**Item No. 7.1.2**  
**Design Review Committee**  
**November 12, 2015**

**SUBJECT:** **Case 20220: Substantial Site Plan Approval, New Pedway and Alterations to Buildings at 1223 Lower Water Street and 5151 Terminal Road, Halifax**

South Pedway Elevation

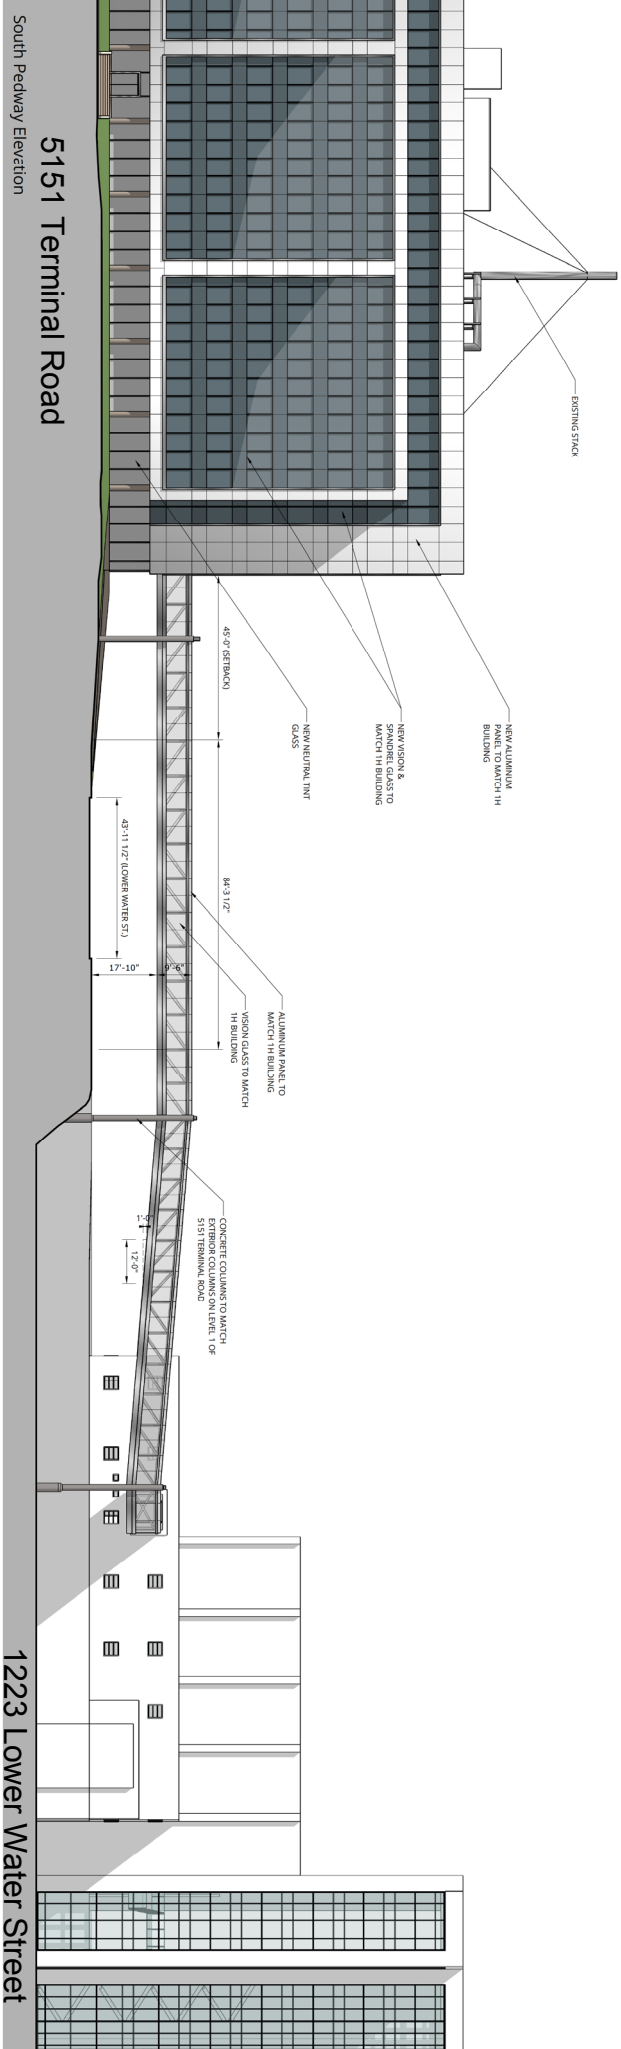
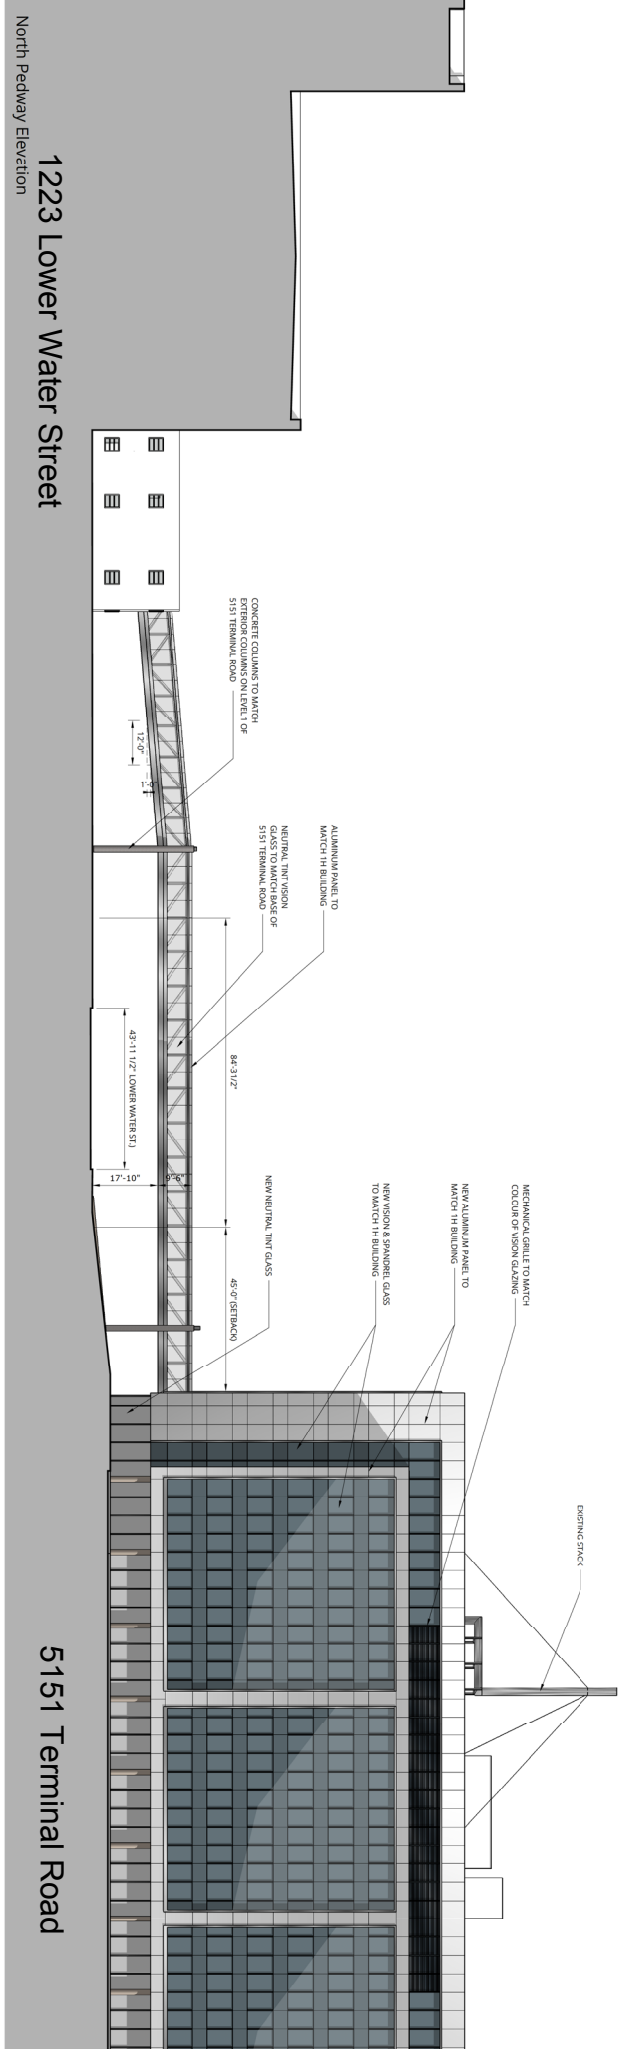
The Design Manual calls for pedways to be constructed of highly transparent materials. Through discussions with the project's architects it has been confirmed that the glass will be of a similar transparency of other pedways that are found in the downtown, which are highly transparent. Therefore, the proposed pedway meets the intent of the Design Manual.

The terminus of Lower Water Street at Terminal Road is identified as *Prominent Visual Terminus Site*, where future design elements on the site of the Westin, during a redevelopment, would be encouraged to highlight the end of this street and view. While the implementation of such design elements would continue to be important in the future, the prominence of this terminus view will be reduced. This will result in the need to introduce different design features that will take into account the views that will be under, through, and over the pedway at different vantage points along Lower Water Street.

The Design Manual calls for pedways to be of exceptionally high design and material quality. As noted in the application submission, care has been taken to design the pedway so that it utilizes the same materials as those that found on the building at 1223 Lower Water Street and that are proposed for 5151 Terminal Road. Therefore, the quality of design and materials for the pedway meets the intent of the Design Manual.
